F3 Freeway to Raymond Terrace

Upgrading the Pacific Highway

**CONCEPT DESIGN SUBMISSIONS REPORT
DECEMBER 2010**

Figure A.7

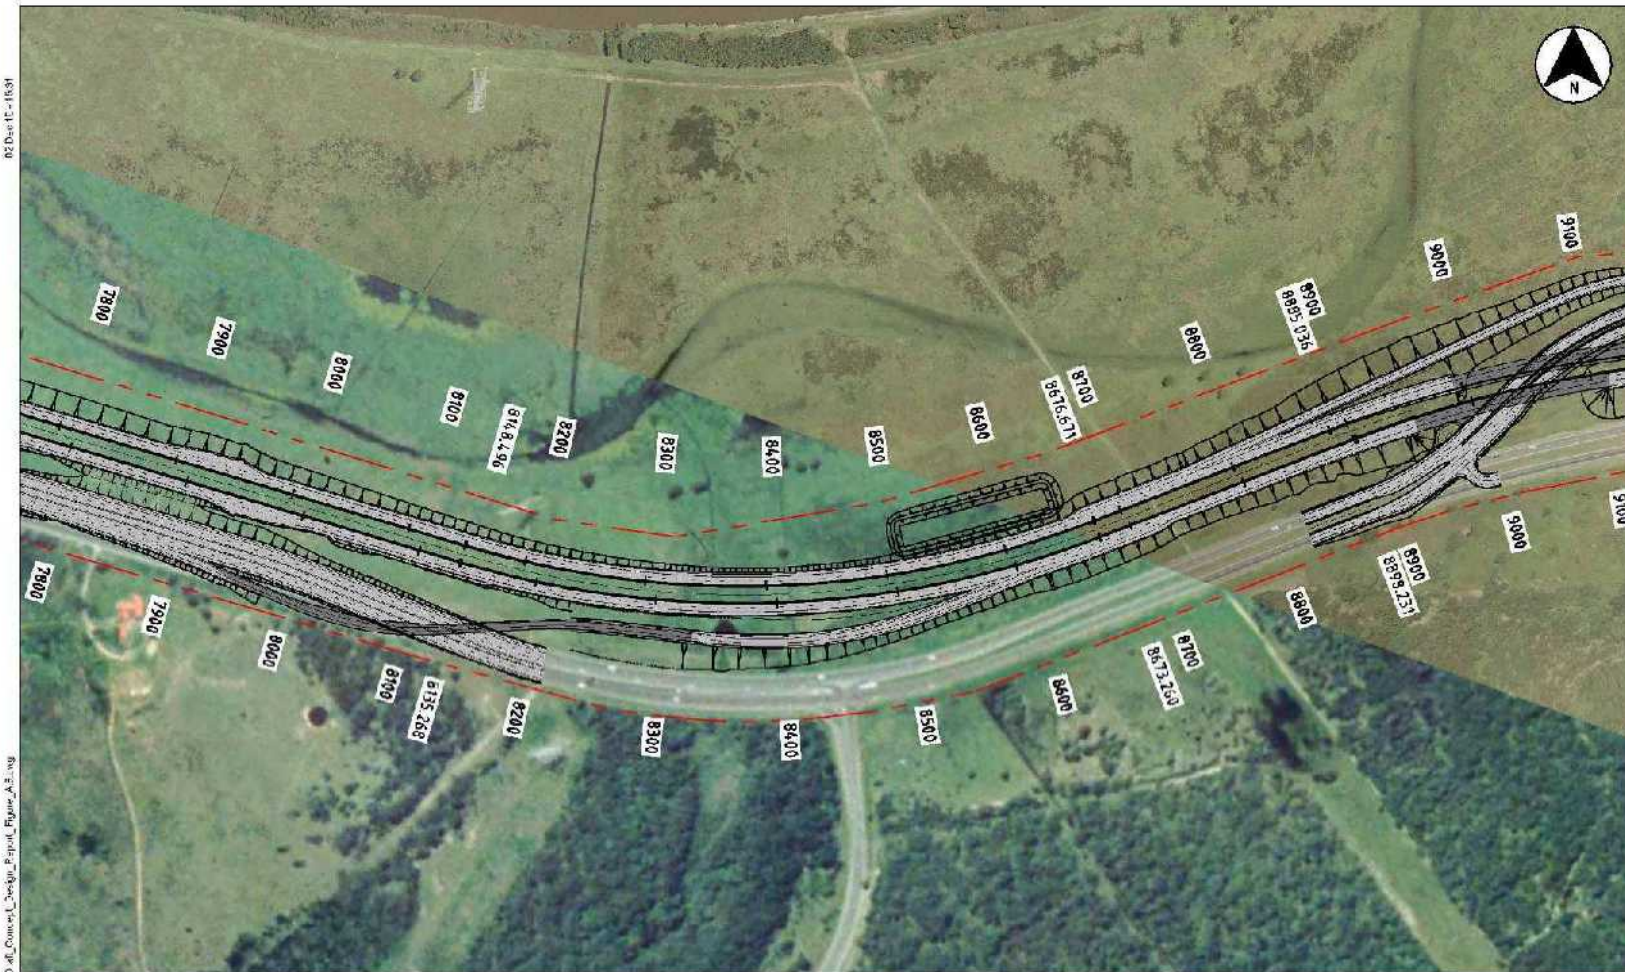
- Impact of the southbound off ramp adjacent to the botanic gardens.
- Complexity of the Tomago interchange.
- Impact of the Tomago interchange on the proposed power station.
- Loss of trade for Heatherbrae businesses as a result of the township being bypassed and the proposed ramp arrangements.

The functionality of the interchange at Tomago is unchanged from that described in the *Concept Design Report* (RTA, 2008). The northbound offload ramp has been shifted further toward Heatherbrae to minimise impact on the proposed power station. The existing highway needs to be realigned away from there to accommodate the northbound off ramp. This arrangement is shown on Figure A.7 in Appendix A.

Figure A.8

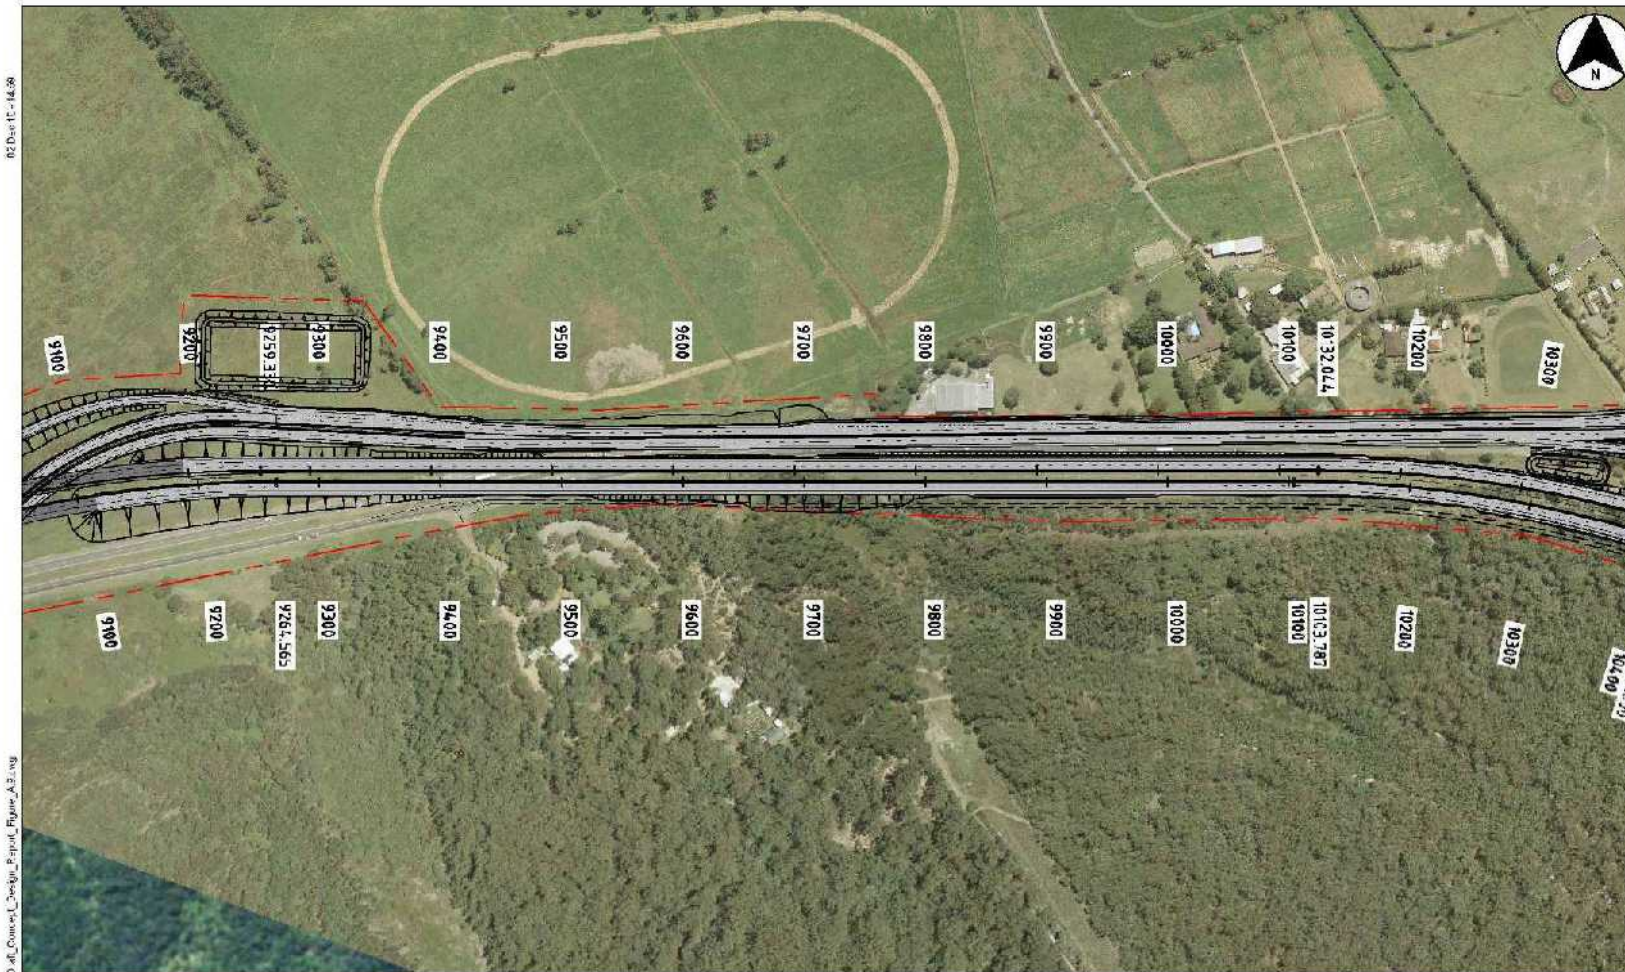
C32, C38, C60, C61, C64, C74, C79, C93, C95, C97, C98, C100, C102, C104, C107, C111, C112, C113, C116, C120, C121, C122, C127, C129, C132, C133, C146, C147, C148	<p>The RTA should select an alternative option to minimise the impact on the HRBG. Options identified included:</p> <ul style="list-style-type: none"> • Move the ramp further south. • Move the ramp further north to encouraging visitors to the gardens, but would also provide ready access to the industrial areas and Newcastle. • Not providing a southbound exit ramp. • Continue to use the existing highway as is. 	The RTA has adopted an alternative concept design which addresses these concerns. See Section 5.2.
C8, C26, C31, C32, C39, C42, C54, C67, C72, C73, C75, C76, C77, C81, C82, C83, C84, C89, C91, C92, C93, C95, C97, C99, C102, C103, C105, C106, C107, C108, C110, C113,	<p>The gardens are a unique asset/resource to the Hunter Valley providing great value to the community. This is compromised by the proposed design. The HRBG has been developed over 22 years as a result of an enormous amount of work by dedicated volunteers, and financial support from local businesses and citizens. This has been completely disregarded by the RTA.</p>	See above. The RTA seeks to address all community concerns that are impacted by its proposal. That has been demonstrated by its willingness to continue dialogue with HRBG to reach the concept as it stands.

The alignments of both the proposed and existing highways have been amended to reduce the impact at the HRBG. The existing highway has been shifted westwards and the new highway is at ground level past the entrance to the HRBG. The alignment of the existing highway is unchanged in plan but would rise over the existing highway to cross south of the entrance to the HRBG. This arrangement is shown on Figures A.8 and A.9 in Appendix A. For the HRBG this has the following advantages:

- Removes the high level viaduct across the frontage of the HRBG and brings the proposed highway down to the same level as the existing.
- Deletes the off ramp which was across the entrance to the HRBG.
- Maintains the entrance to the HRBG off the existing highway, but moves it south so that visitors must turn in and travel along a disused part of the existing highway before arriving at the entrance.
